ADDENDUM 2
REMEDIAL INVESTIGATION/FEASIBILITY STUDY
WORK PLAN

Lehigh Valley Railroad Derailment Superfund Site

LeRoy, New York

October 30, 2009

RI/FS WP Addendum 2 Figure 1

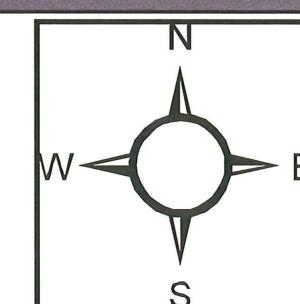
Monitoring wells will be installed at the 17 locations shown on Figure 1, designated LVRR-18 through LVRR-35. The rationale for selecting each of these locations is provided on Table 1.

Figure 2a

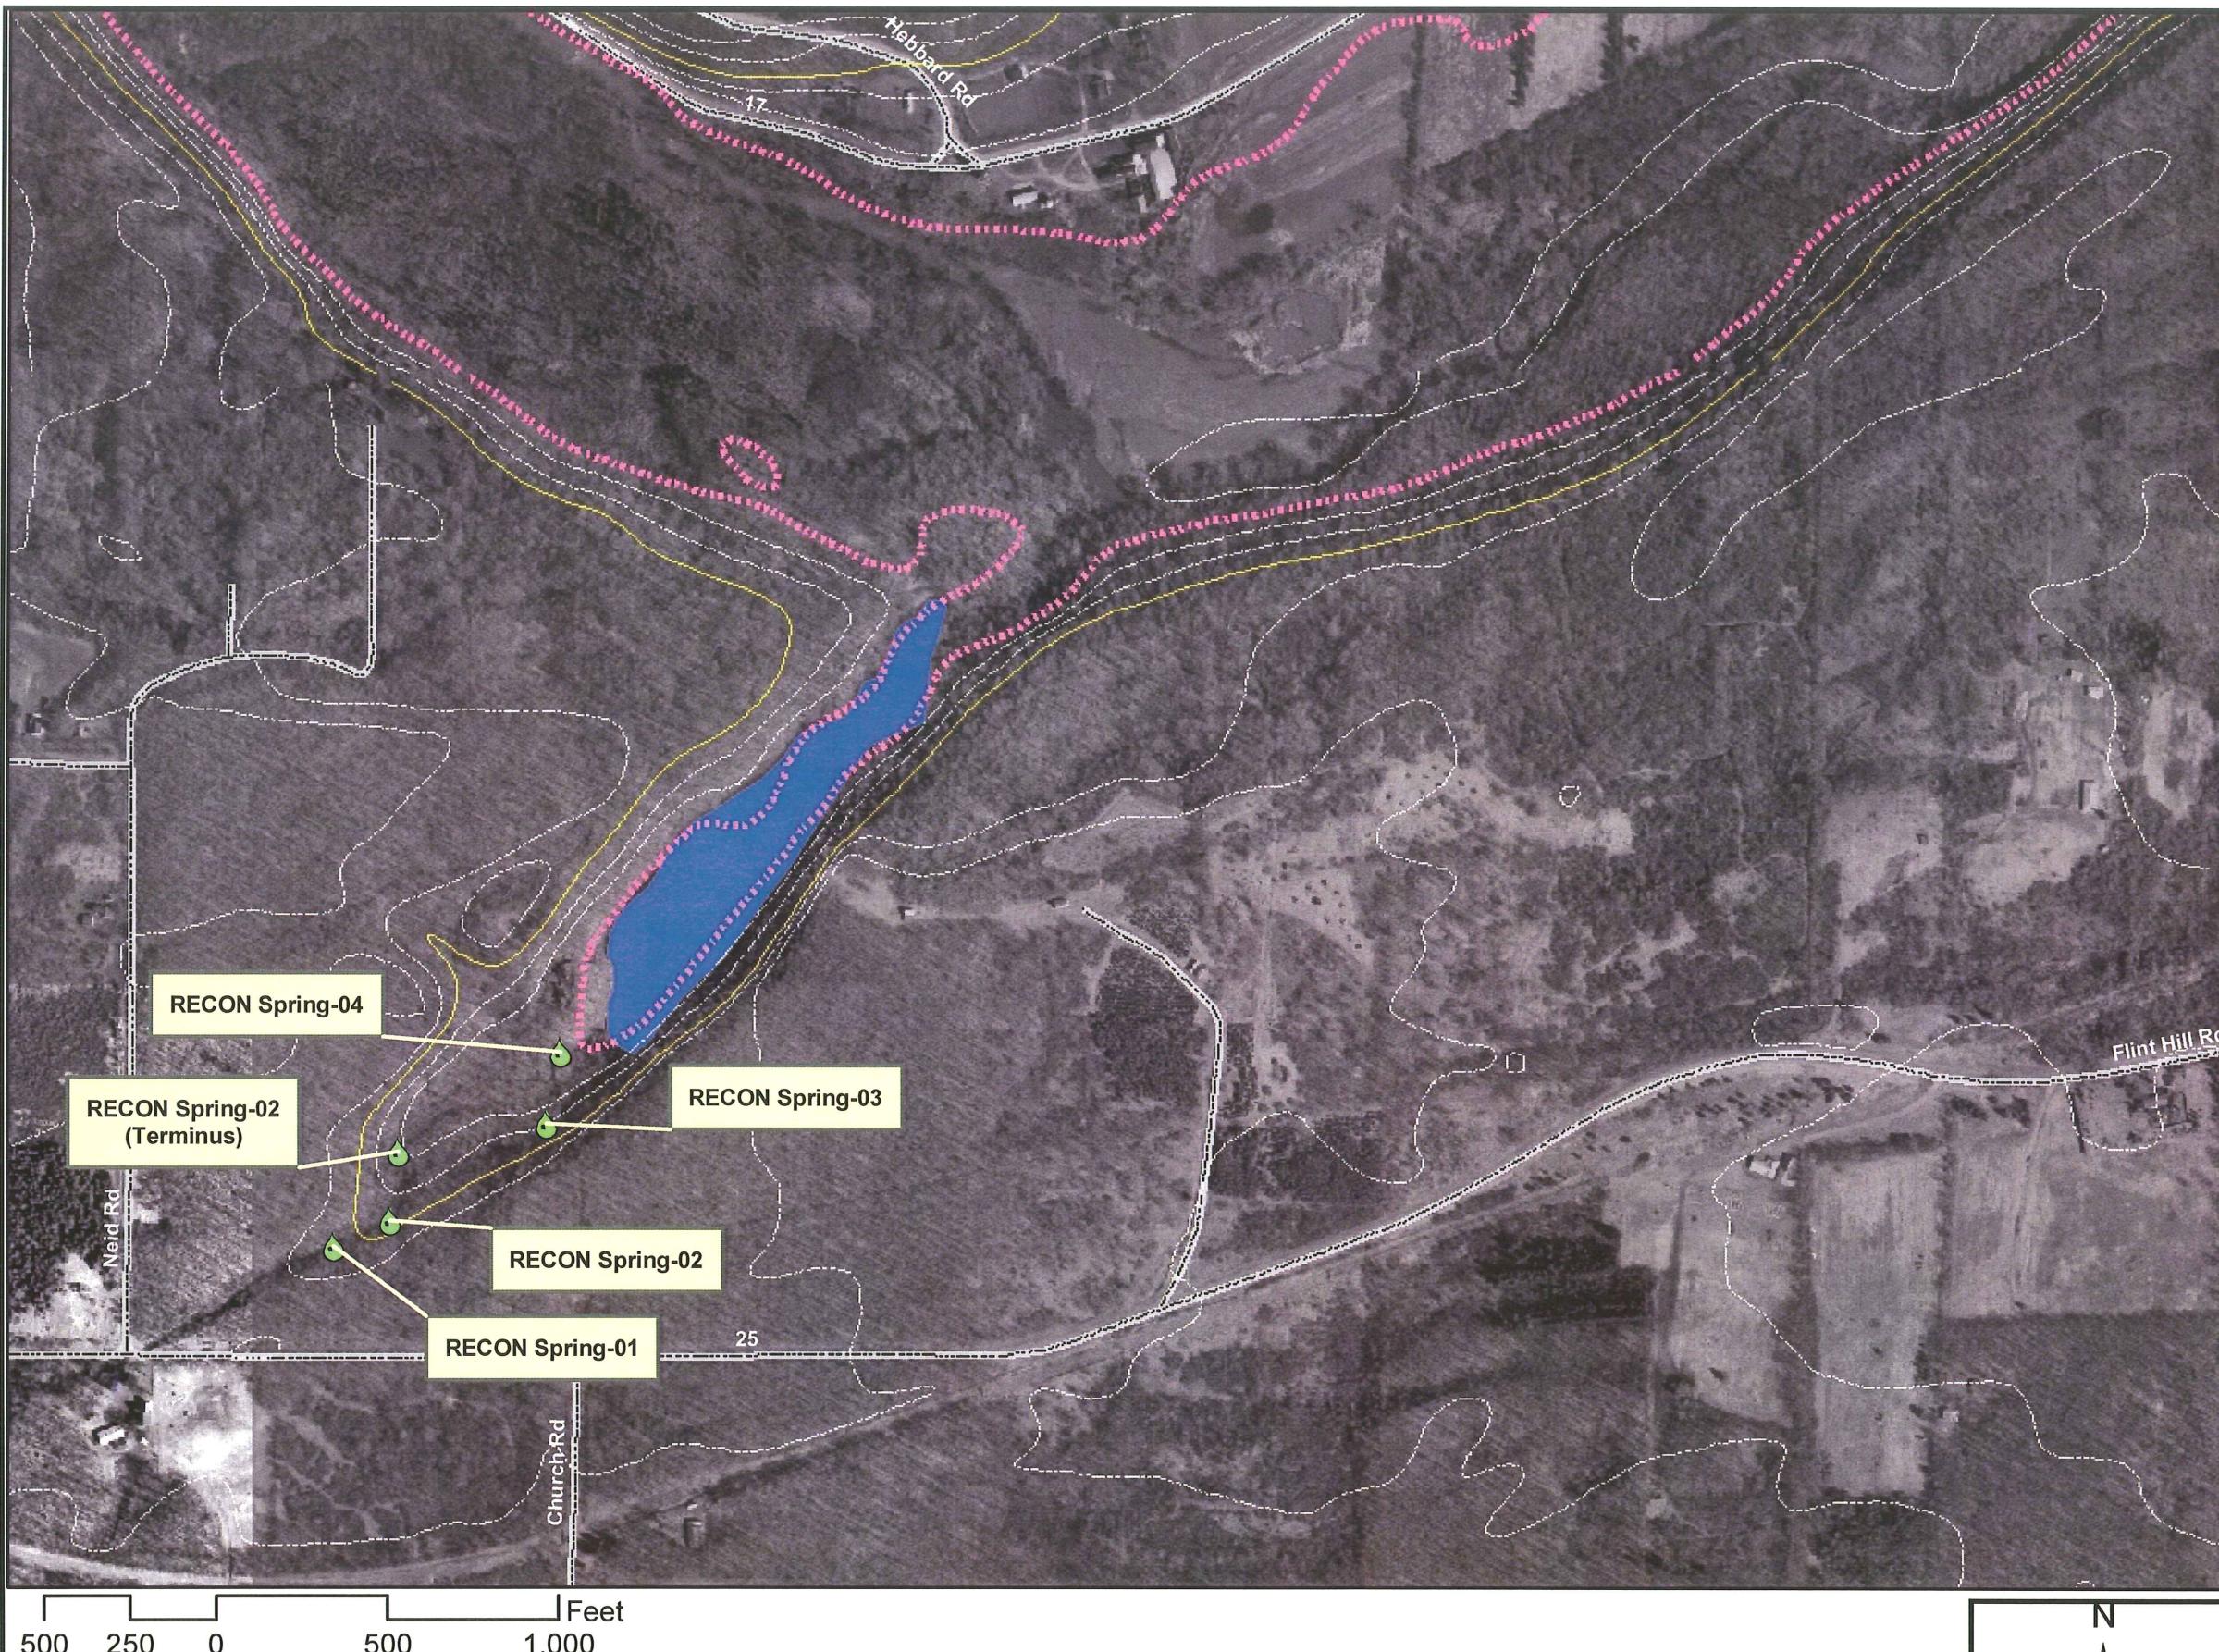
Water samples, and sediment samples if present, will be collected at the 17 spring/seep locations listed on Table 2. These 17 locations are indicated on Figures 2a, 2b and 2c.

RI/FS WP Addendum 2
Figure 3a

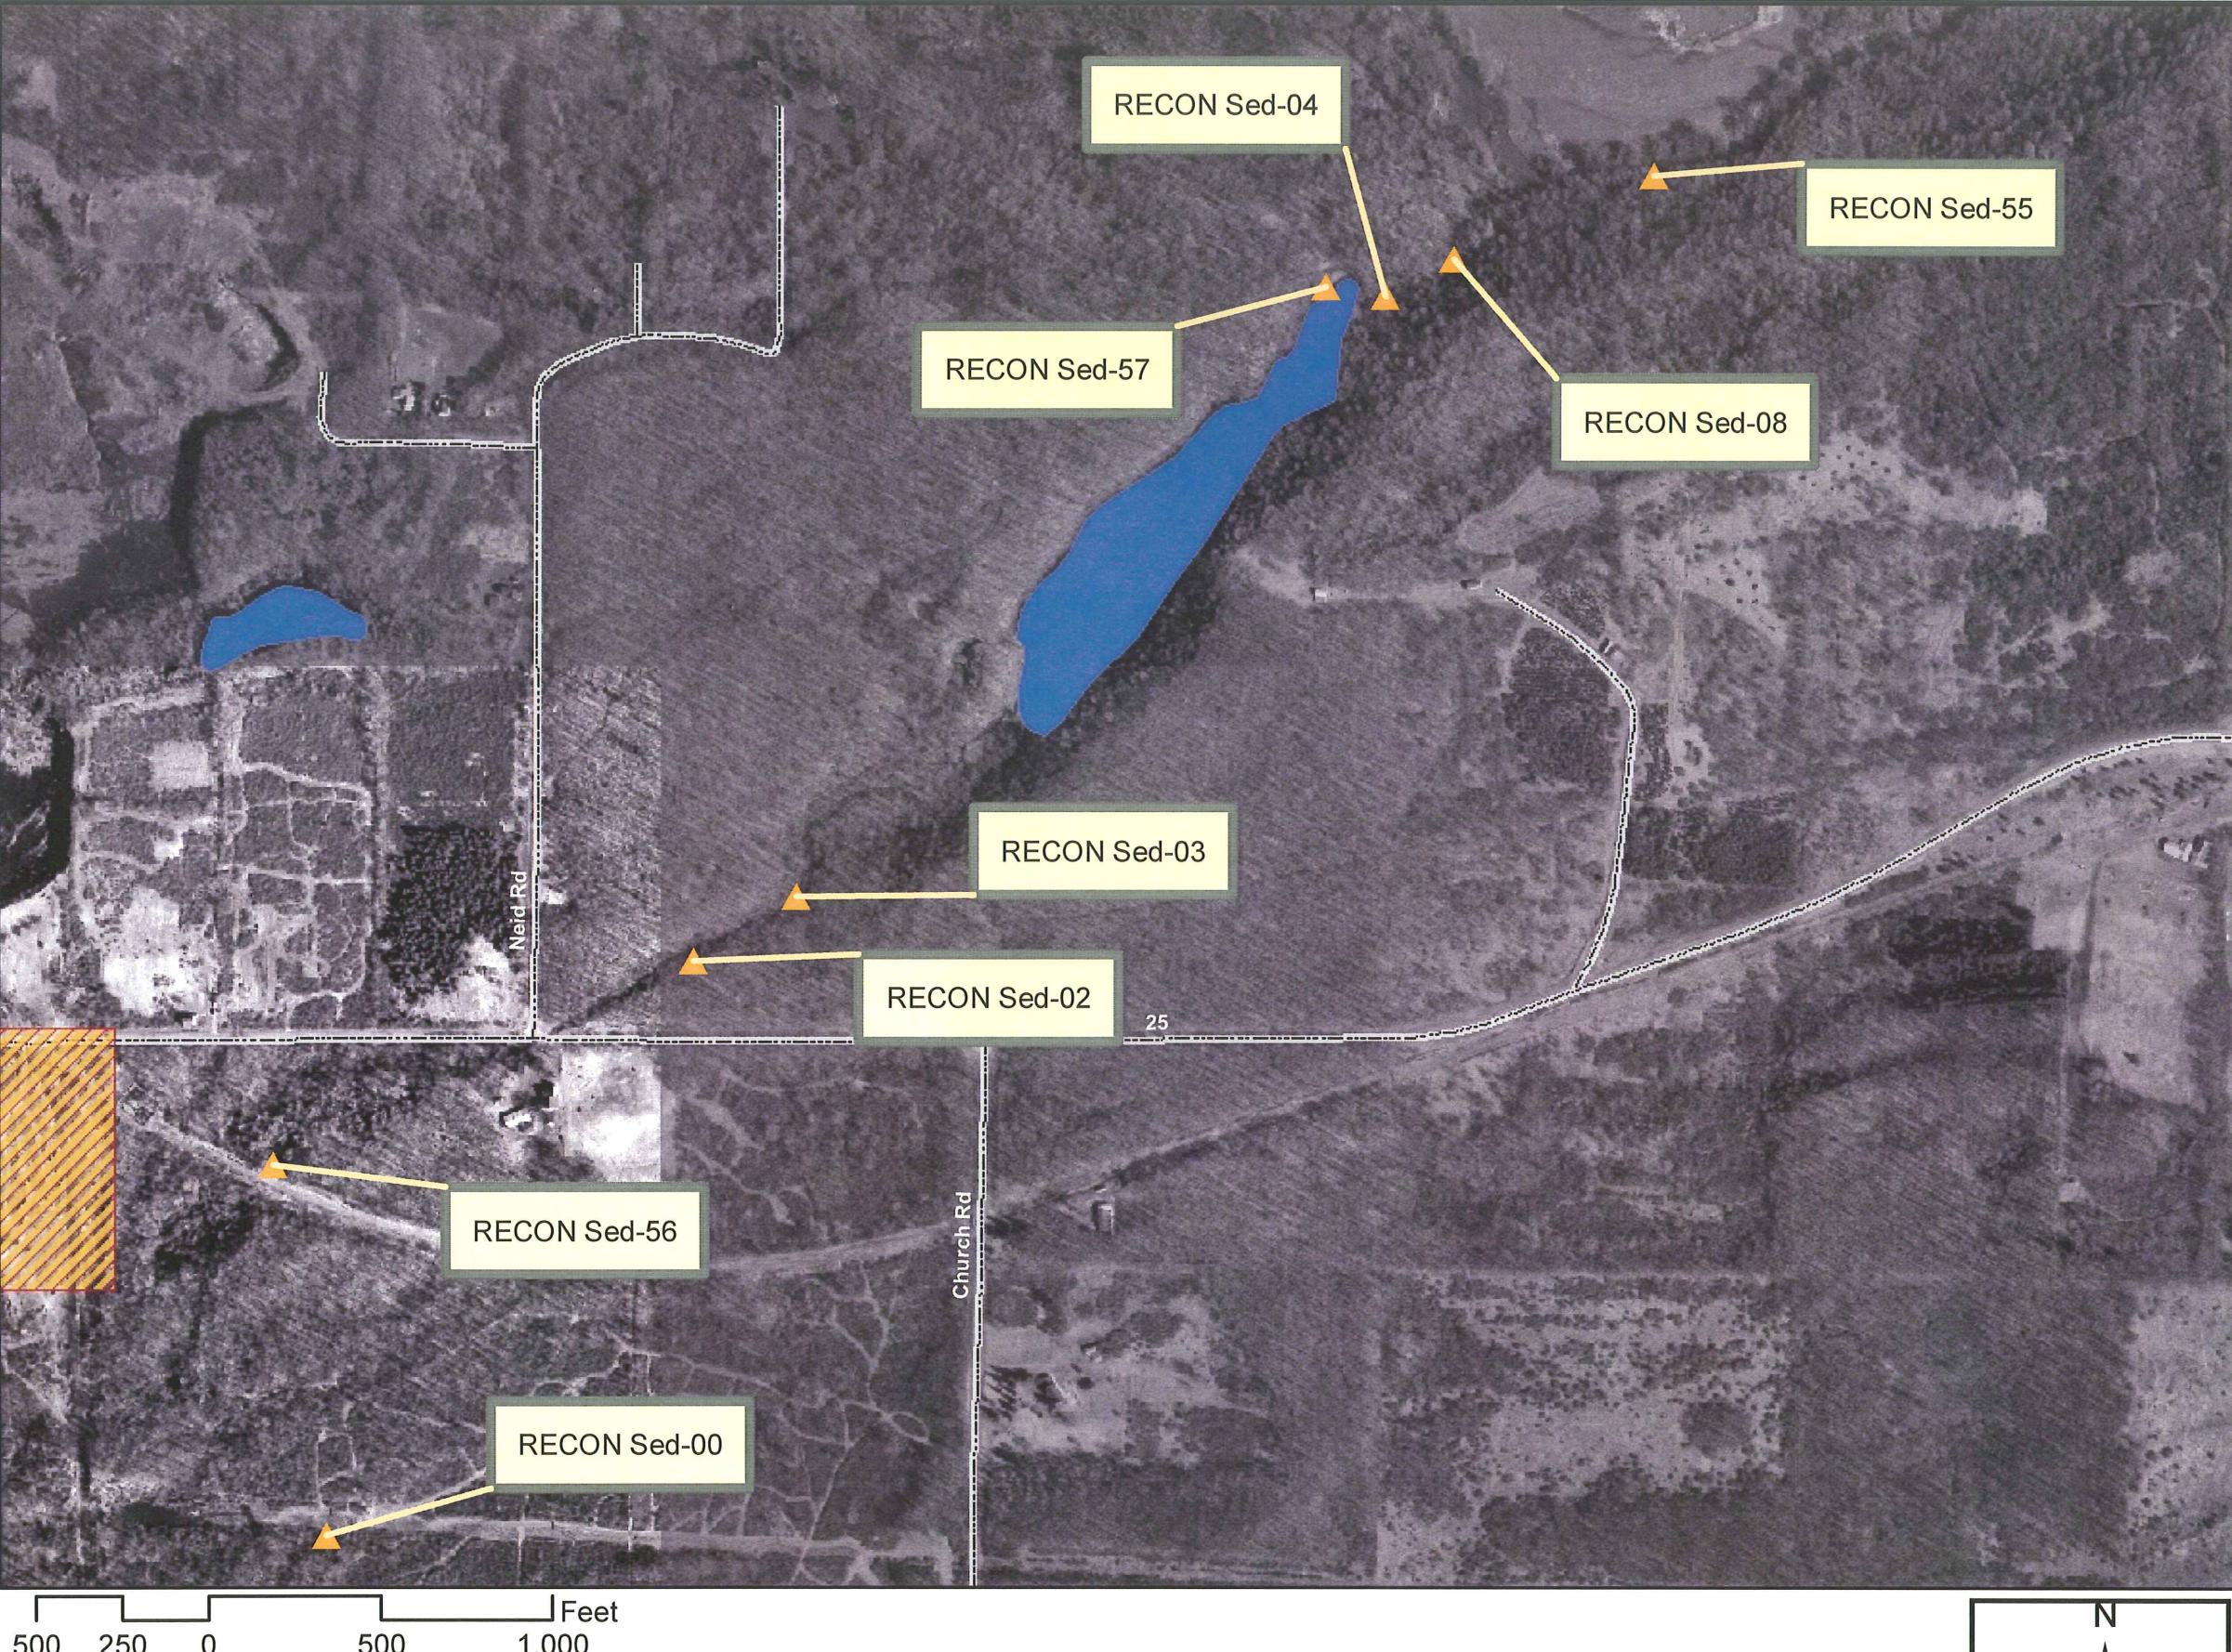
Sediment samples will be collected from the 37 locations listed on Table 3 and shown on Figures 3a, 3b, 3c, and 3d.
